V2500 Propulsion System — Nacelle

SERVICE BULLETIN

Subject: Transmittal of Revision 4 to Service Bulletin Number V2500-NAC-78-0109

**NACELLE - EXHAUST - CASCADES, THRUST REVERSER - MODIFICATION AND
REPLACEMENT OF**

**LEFT HAND UPPER THRUST REVERSER HALF CASCADE REMOVAL
FIGURE 1**

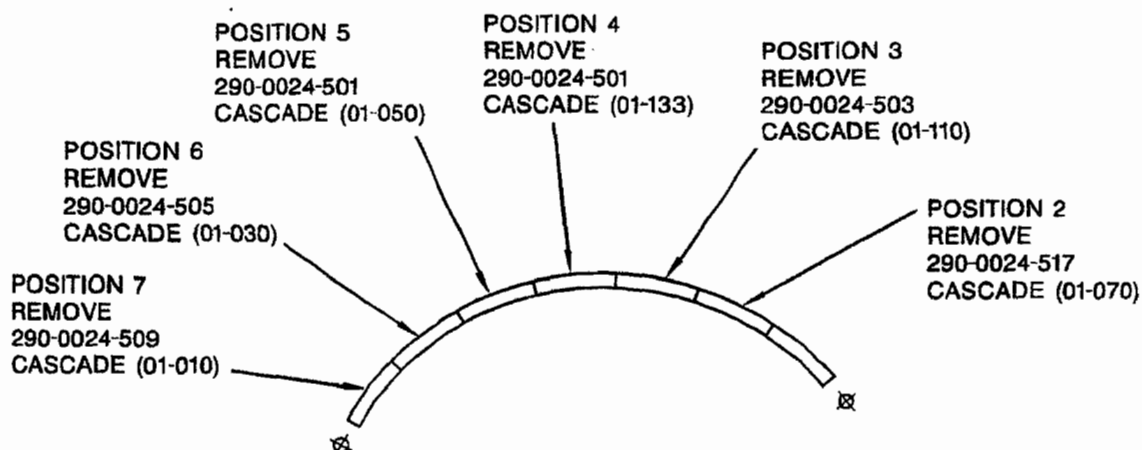
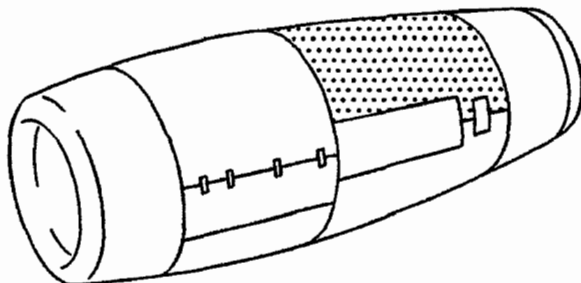
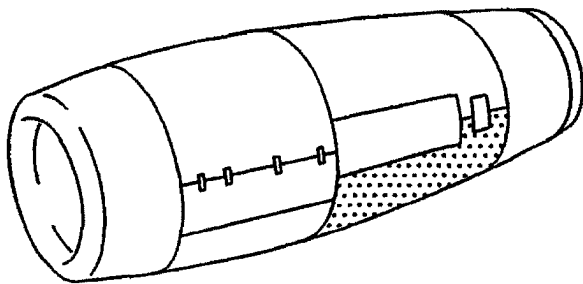
- (1) Remove eight NAS6404U11 bolts, eight NAS1587-4C washers, and the 290-0024-517 cascade from left hand thrust reverser position 2. Scrap cascade. Retain bolts and washers for installation. Refer to Figure 1.
- (2) Remove and modify 290-0024-503 cascade from left hand thrust reverser position 3.
 - (a) Remove eight NAS6404U11 bolts, eight NAS1587-4C washers, and the 290-0024-503 cascade from left hand thrust reverser position 3. Retain bolts and washers for installation.

LEFT HAND LOWER THRUST REVERSER HALF CASCADE REIDENTIFICATION
FIGURE 2

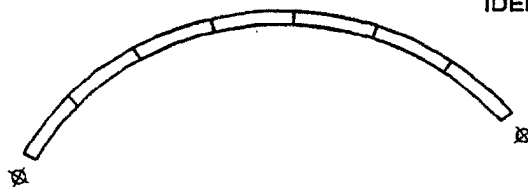
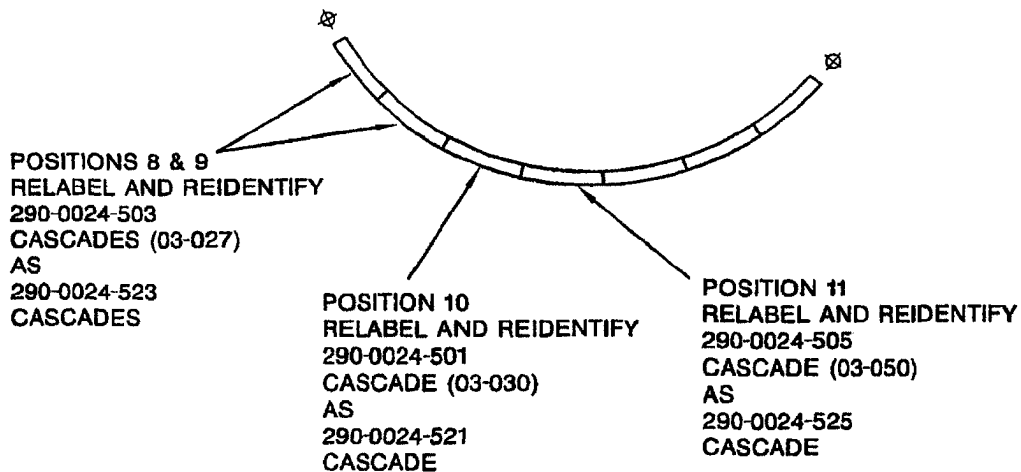
- (6) Modify 290-0024-503 cascades at left hand thrust reverser positions 8 and 9. Refer to Figure 2.
 - (a) Remove labels from 290-0024-503 cascades.
 - (b) Install 290-0030-523 labels onto 290-0024-503 cascades.

- (c) Identify newly labeled cascades as 290-0024-523 cascades with ink stamp and white ink (CoMat 06-073).
- (7) Modify 290-0024-501 cascade at left hand thrust reverser position 10.

- (a) Remove label from 290-0024-501 cascade.
 - (b) Install 290-0030-521 label onto 290-0024-501 cascade.
 - (c) Identify newly labeled cascade as 290-0024-521 cascade with ink stamp and white ink (CoMat 06-073).

- (8) Modify 290-0024-505 cascade at left hand thrust reverser position 11.
 - (a) Remove label from 290-0024-505 cascade.
 - (b) Install 290-0030-525 label onto 290-0024-505 cascade.

- (c) Identify newly labeled cascade as 290-0024-525 cascade with ink stamp and white ink (CoMat 06-073).
- (9) Overcoat newly installed 290-0030 labels and ink stamps with clear polyurethane (CoMat 07-098).

**LEFT HAND UPPER THRUST REVERSER HALF CASCADE INSTALLATION
FIGURE 3**

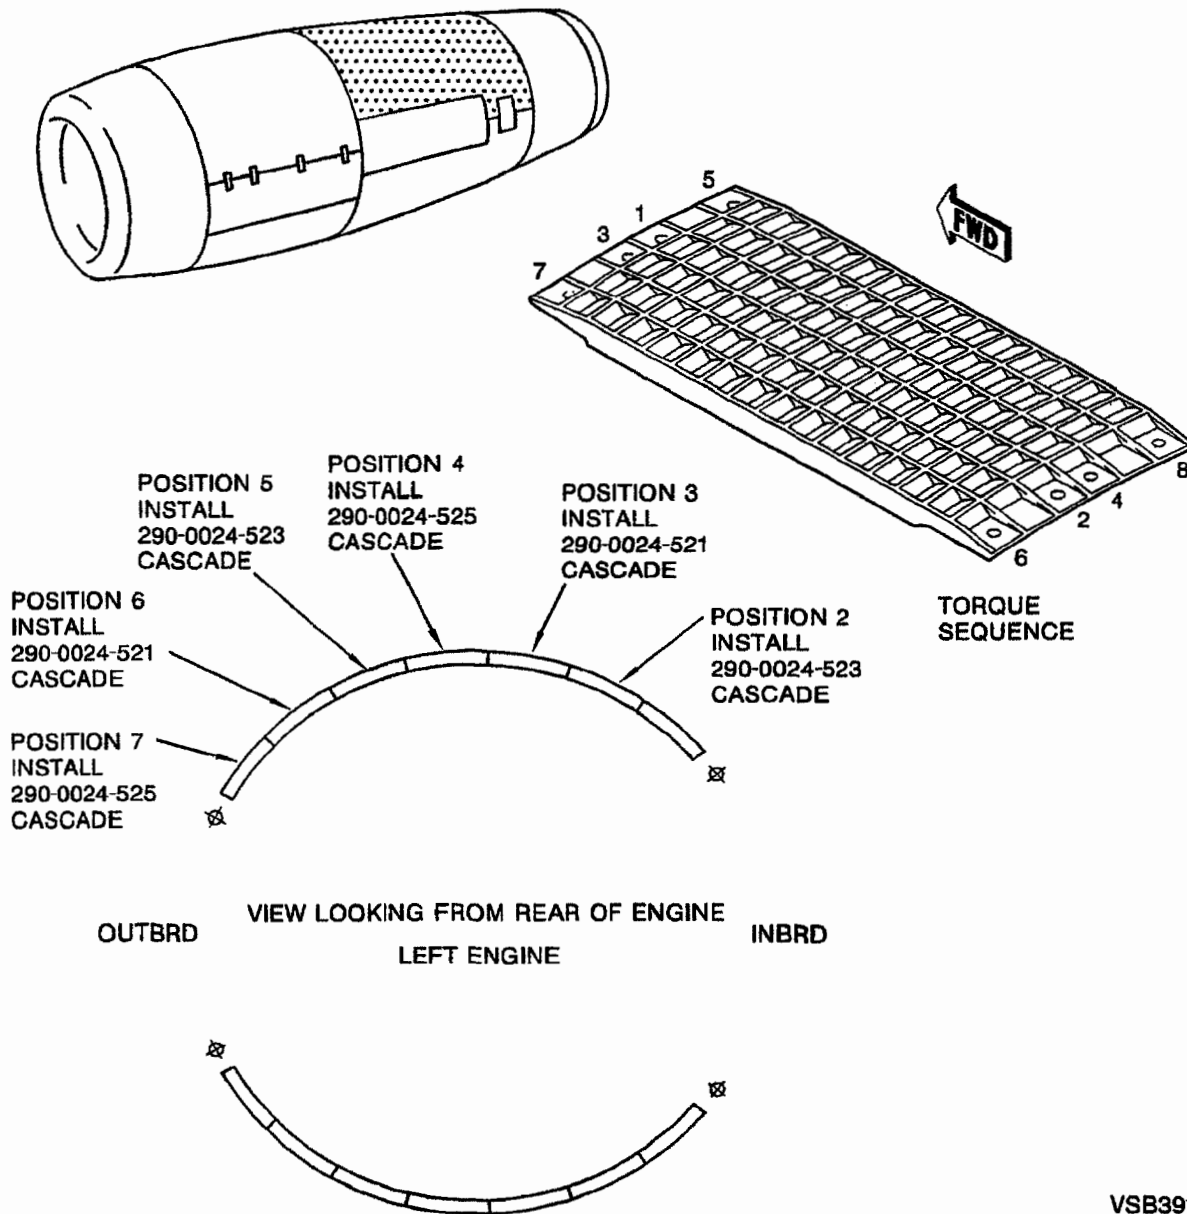
- (d) Use a heat lamp to cure the polyurethane at 140-180 deg F (60-82 deg C) for 1 hour.
- (10) Install cascades on the left hand thrust reverser.
- (a) At position 2 on the thrust reverser, install a 290-0024-523 cascade with eight NAS6404U11 bolts and eight NAS1587-4C washers. Tighten bolts finger tight only. Refer to Figure 3.

- (b) At position 3 on the thrust reverser, install a 290-0024-521 cascade with eight NAS6404U11 bolts and eight NAS1587-4C washers. Tighten bolts finger tight only.

- (c) At position 4 on the thrust reverser, install a 290-0024-525 cascade with eight NAS6404U11 bolts and eight NAS1587-4C washers. Tighten bolts finger tight only.

- (d) At position 5 on the thrust reverser, install a 290-0024-523 cascade with eight NAS6404U11 bolts and eight NAS1587-4C washers. Tighten bolts finger tight only.

- (e) At position 6 on the thrust reverser, install a 290-0024-521 cascade with eight NAS6404U11 bolts and eight NAS1587-4C washers. Tighten bolts finger tight only.

- (f) At position 7 on the thrust reverser, install a 290-0024-525 cascade with eight NAS6404U11 bolts and eight NAS1587-4C washers. Tighten bolts finger tight only.
- (g) Tighten the NAS6404U11 bolts on each cascade in positions 2 through 7 to 50-70 in-lb (5.649-7.909 Nm) in the sequence shown in Figure 3.

**RIGHT HAND UPPER THRUST REVERSER HALF CASCADE REMOVAL
FIGURE 4**

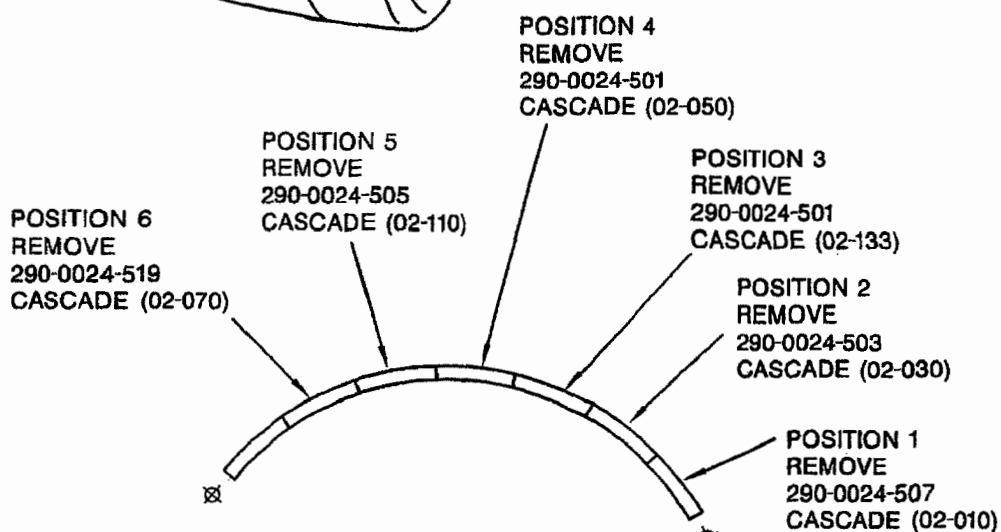
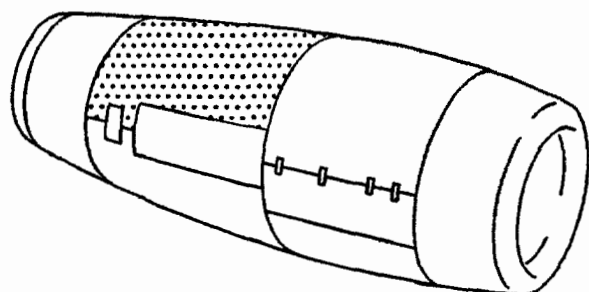
- (11) Remove eight NAS6404U11 bolts, eight NAS1587-4C washers, and the 290-0024-507 cascade from right hand thrust reverser position 1. Scrap cascade. Retain bolts and washers for installation. Refer to Figure 4.
- (12) Remove and modify 290-0024-503 cascade from right hand thrust reverser position 2.
 - (a) Remove eight NAS6404U11 bolts, eight NAS1587-4C washers, and the 290-0024-503 cascade from right hand thrust reverser position 2. Retain bolts and washers for installation.
 - (b) Remove label from 290-0024-503 cascade.
 - (c) Install 290-0030-523 label onto 290-0024-503 cascade.
 - (d) Identify newly labeled cascade as 290-0024-523 cascade with ink stamp and white ink (CoMat 06-073).
- (13) Remove and modify 290-0024-501 cascade from right hand thrust reverser position 3.

RIGHT HAND LOWER THRUST REVERSER HALF CASCADE REIDENTIFICATION
FIGURE 5

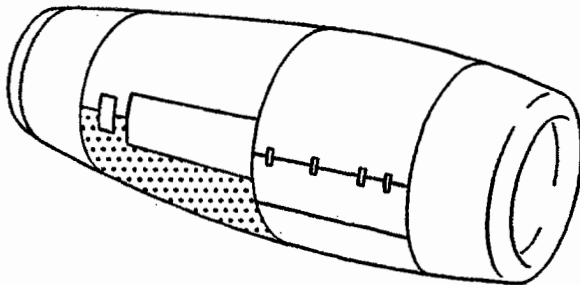
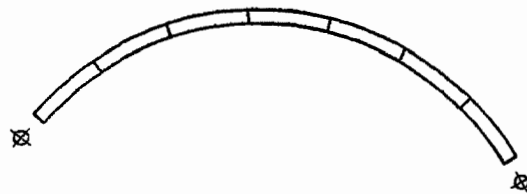
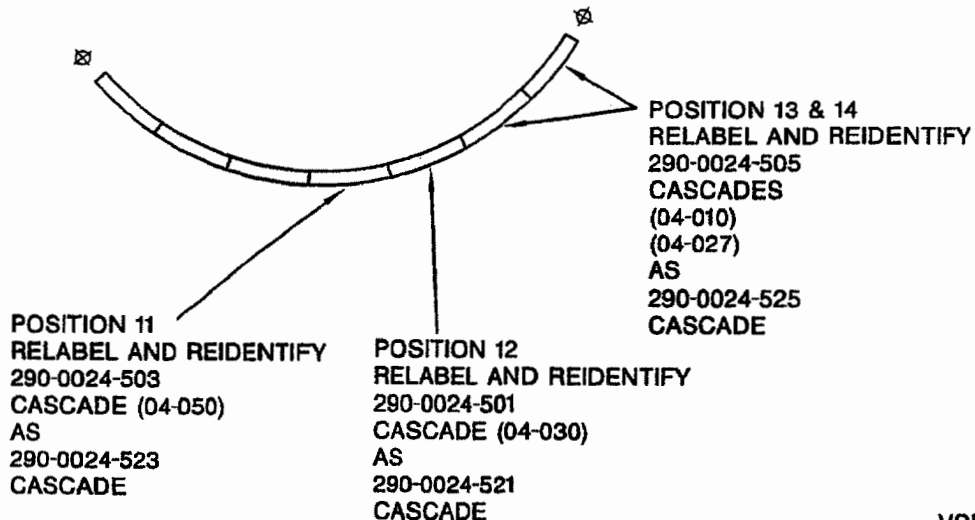
(17) Modify 290-0024-503 cascade at right hand thrust reverser position 11. Refer to Figure 5.

(18) Modify 290-0024-501 cascade at right hand thrust reverser position 12.

(19) Modify 290-0024-505 cascade at right hand thrust reverser positions 13 and 14.

RIGHT HAND UPPER THRUST REVERSER HALF CASCADE INSTALLATION
FIGURE 6

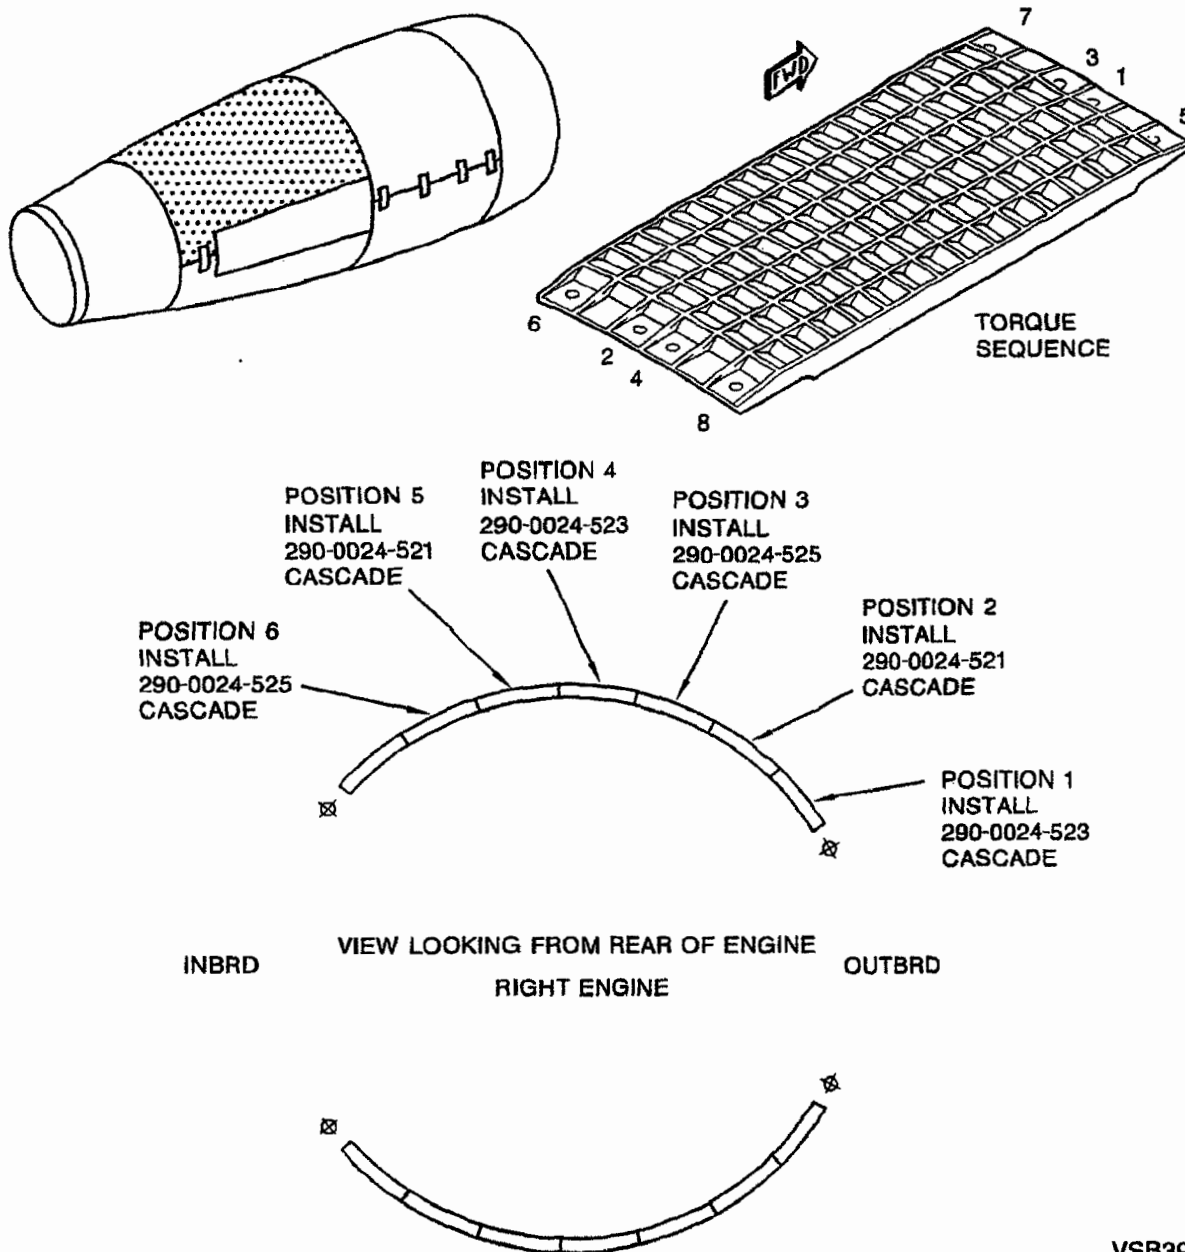
- (d) Use a heat lamp to cure the polyurethane at 140-180 deg F (60-82 deg C) for 1 hour.
- (21) Install cascades on the right hand thrust reverser.
- (a) At position 1 on the thrust reverser, install a 290-0024-523 cascade with eight NAS6404U11 bolts and eight NAS1587-4C washers. Tighten bolts finger tight only. Refer to Figure 6.

- (b) At position 2 on the thrust reverser, install a 290-0024-521 cascade with eight NAS6404U11 bolts and eight NAS1587-4C washers. Tighten bolts finger tight only.

- (c) At position 3 on the thrust reverser, install a 290-0024-525 cascade with eight NAS6404U11 bolts and eight NAS1587-4C washers. Tighten bolts finger tight only.

- (d) At position 4 on the thrust reverser, install a 290-0024-523 cascade with eight NAS6404U11 bolts and eight NAS1587-4C washers. Tighten bolts finger tight only.
- (e) At position 5 on the thrust reverser, install a 290-0024-521 cascade with eight NAS6404U11 bolts and eight NAS1587-4C washers. Tighten bolts finger tight only.
- (f) At position 6 on the thrust reverser, install a 290-0024-525 cascade with eight NAS6404U11 bolts and eight NAS1587-4C washers. Tighten bolts finger tight only.
- (g) Tighten the NAS6404U11 bolts on each cascade in positions 2 through 6 to 50-70 in-lb (5.649-7.909 Nm) in the sequence shown in Figure 6.
- (h) Re-identify the thrust reversers as follows:
 - 290-0003-517 as 290-0003-525
 - 290-0003-519 as 290-0003-527
 - 290-0003-521 as 290-0003-529
 - 290-0003-523 as 290-0003-531
